DONALD C. COOK NUCLEAR PLANT

CDR: [Signature] DATE: 1/27/82 DWG. NO. 1-NSW-58

1NSW-58 (sheet 2 of 2)  
Lower Containment Ventilation  
Unit 4 Supply Line

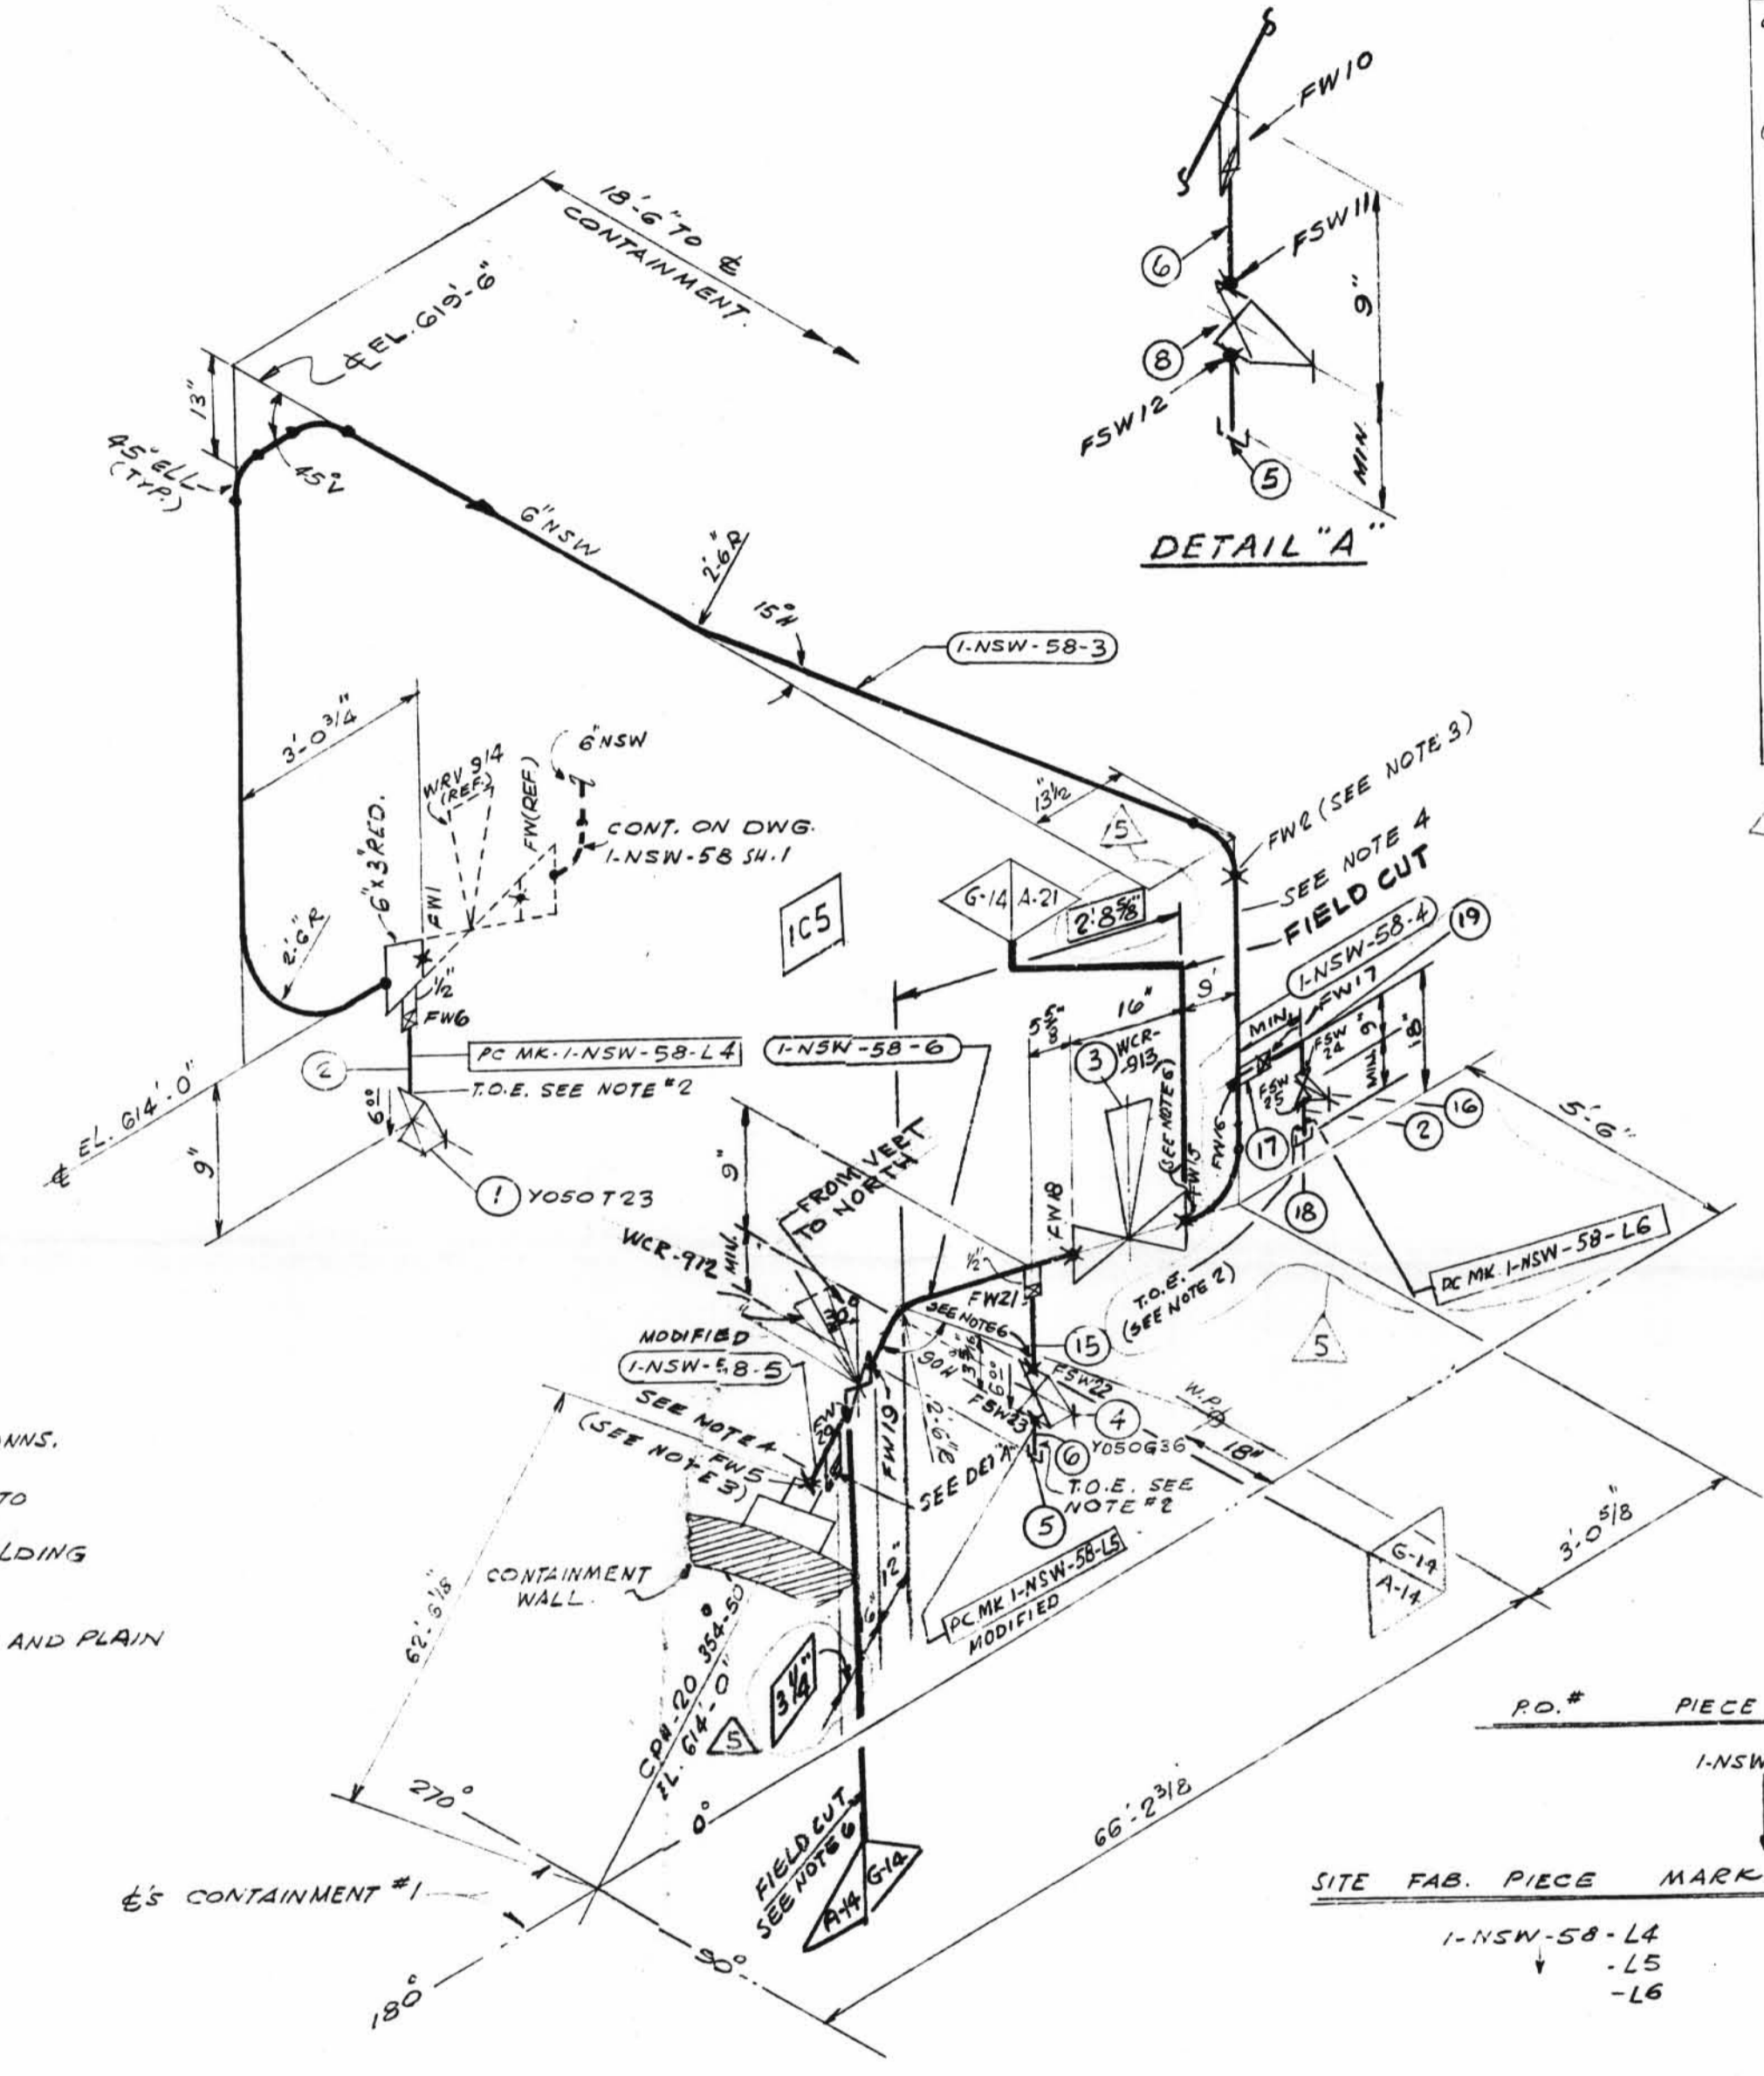
REV	DATE	DR	DESCRIPTION	REMARKS
1	7/19/75	P.C.A.	REVD.; ITEM #4 Y050436 WAS CY050436-REV'D. BY AEP.	NO ACTION REQ'D.
2	1-20-76	H.M.	REVISED BY A.E.P. DESIGN PER RFC-DC-12-671 TO REFLECT AS BUILT WHEN CHECK VALVE WAS ADDED	NO ACTION REQ'D.
3	2/12/78	H.B. LB	PER RFC #12-1430 DELETE ITEM (7) & ADDED ITEM (9) (10) (11) (12) (13) SEE DETAIL 'B'.	FIELD ACTION REQ'D.
4	1/13/82	A.G. DR.	PER RFC-DC-12-2549 ADDED PIPE SPEC. G-14. DIM'S. PCMK 616 FIELD WELD BOX. NOTES G & 7. FW 15 THRU 21, FSW 22 THRU 25. ITEM NOS 14 THRU 18 TO B/M. DELETED ITEM NOS 9 THRU 13 IN B/M. REVISED ITEM 3 IN B/M. MODIFIED PCMK'S 5 & 6.	FIELD ACTION REQ'D.
5	1/28/82	E.G. JM	PER RFC-DC-12-2549 BOXED DIMENSIONS INDICATE FIELD WELD. RELOCATED TEST CONN. & ADDED ITEM 19 TO B/M. PER FIELD	FIELD ACTION REQ'D.
